The U.S. Army Corps of Engineers, Portland District (Corps) Draft Final Engineering Documentation Report, "Juvenile PIT Tag Detection Prototype for Precision Increase," is available for your review and comment.

Bonneville Lock and Dam

Juvenile PIT Tag Detection Prototype for Precision Increase

Draft Final Review

Figure 6-1. B1 ITS Fixed Gate Flat-Plate Antenna

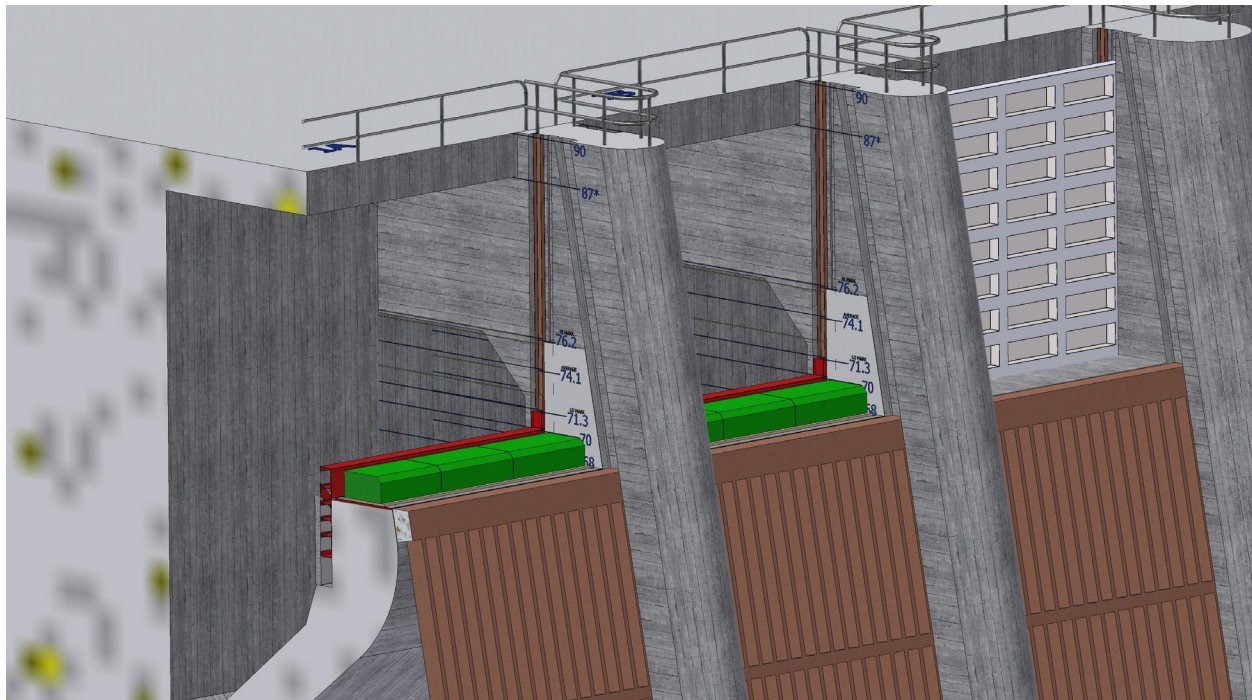
2. Figure 6-1 - We'll send you a new graphic that doesn't include the floating antennas. It does include shielding described in the next comment.

New graphic was used to replace the existing graphic in the report.

Figure 6-2. B1 ITS Fixed Gate Pass-Through Antenna

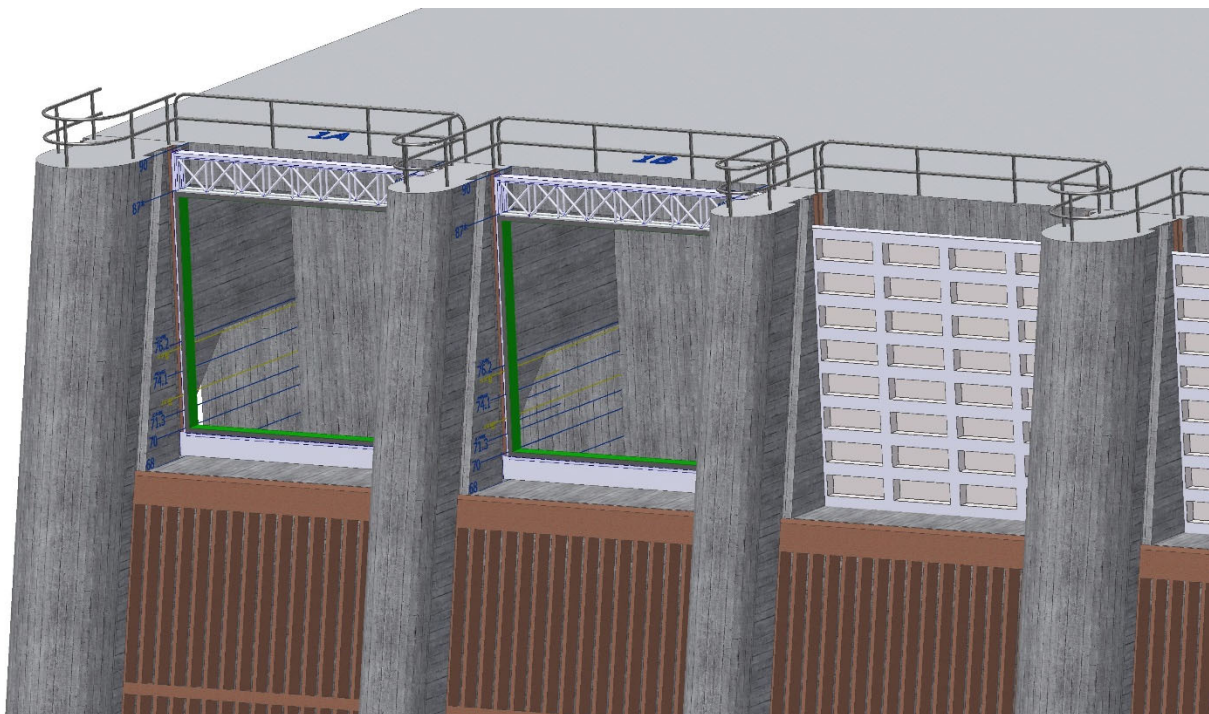
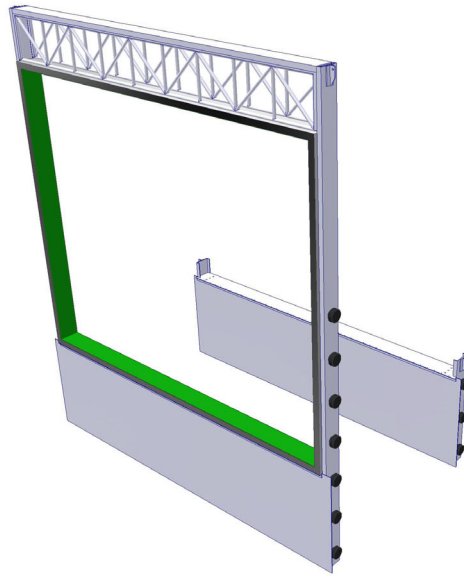
5. Section 6.2.6 – We envision the pass-through antenna design to include the gate. Referring to Figure 6-2, in Bay 1A the antenna is fixed at 68' msl as per the fish passage plan (FPP). The gate portion (on the bottom of the antenna assembly) is in the gate slot and thus not seen. In Bay 1B, part of the gated is visible as that antenna is fixed at 70' msl as per the FPP. In both cases the gates are available for use by pulling the antenna assemblies upward.

Figure 6-7. Spillway Ogee Flat-Plate Antenna Array

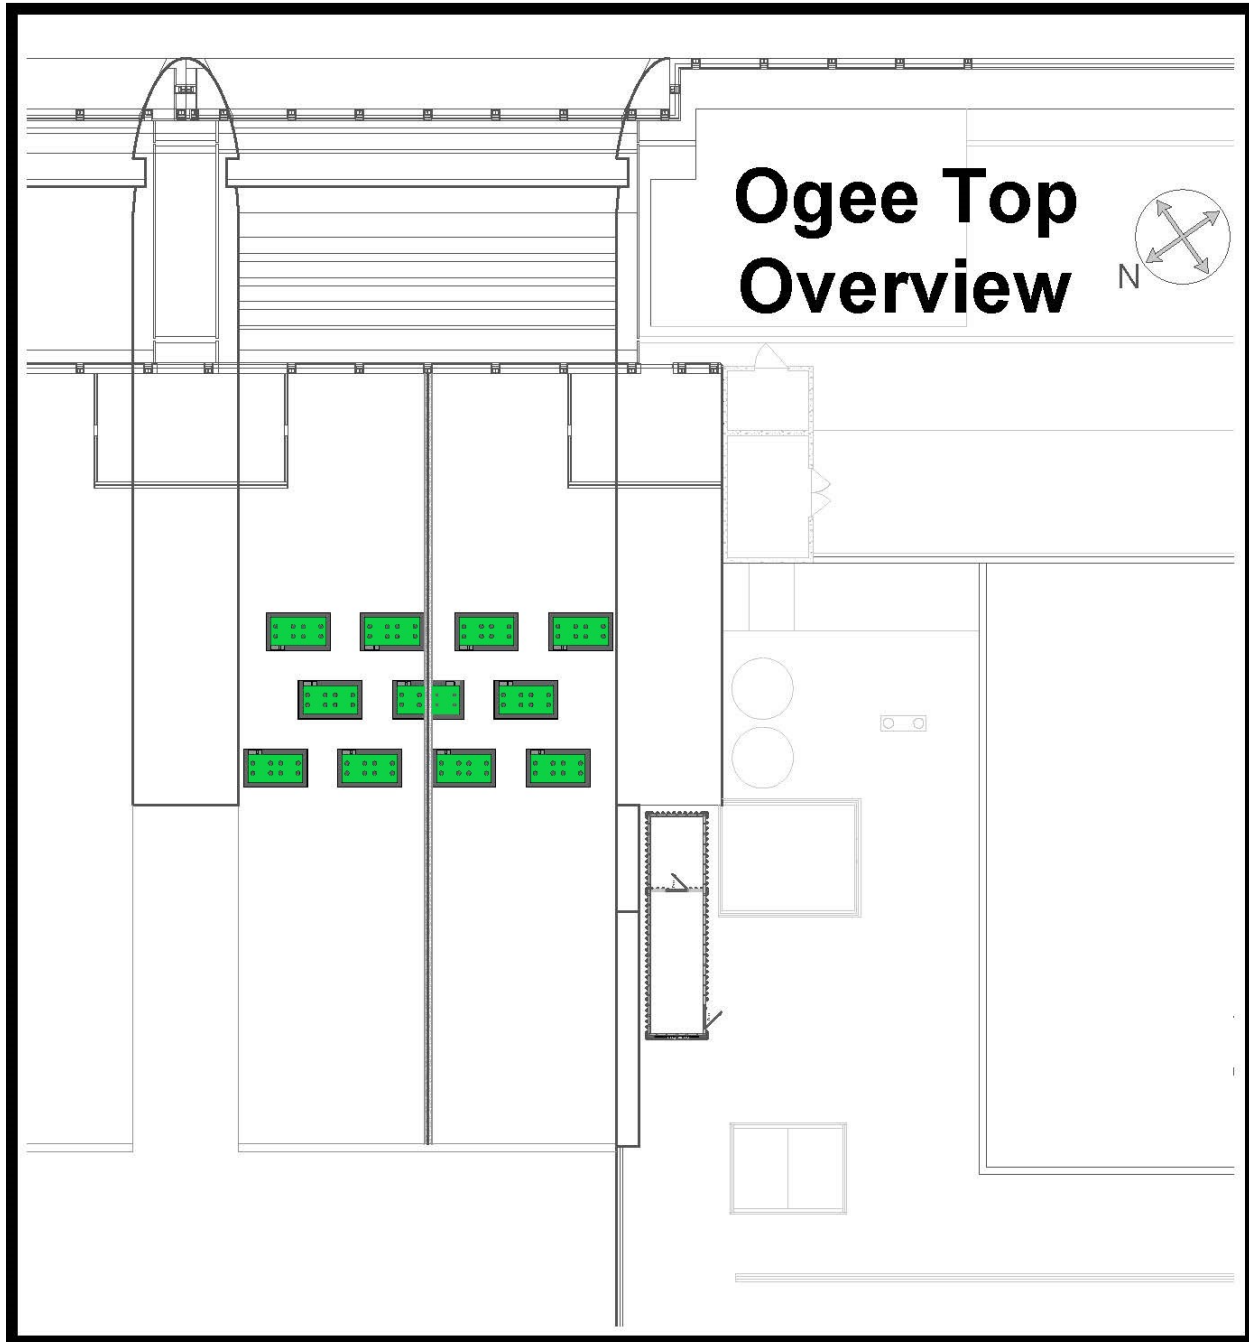
Alternative 7: This one is not comparable to LWG antenna design. The RSW passes 10 kcfs and the spillways at BON will vary much more than that. There is also the problem of the potential for a 30 foot change in tailrace at BON which can never occur at LWG.

Agreed. The PDT considered these differences between the LWG and BON spillway bays and concluded that the BON bays were very different hydraulically and structurally and an antenna in this location would therefore perform quite poorly. This is reflected in the final score for the spillway antenna alternative. Verbiage was also added to Alternative 7.

Figure 6-8. B2CC Additional Pass-Through Antenna

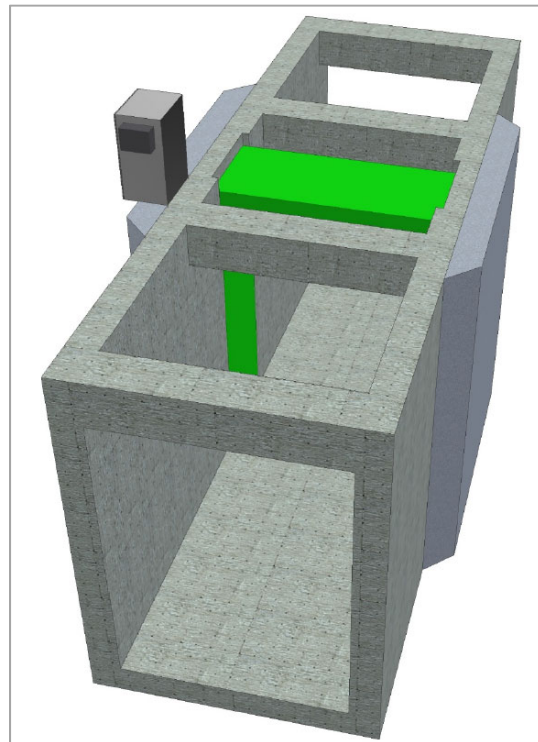
Alternative 8: I believe the current antenna was built with a thought of adding in a second antenna very close to it. I was surprised to see the second antenna so far from it. I also did see if they thought was to cut out that section and replace with non-ferrous aggregate or just cut a trench and use ferrite tiles for the shielding? The current antenna cost close to \$10 million to build.

Language added to Section 6.8.1 to address this.
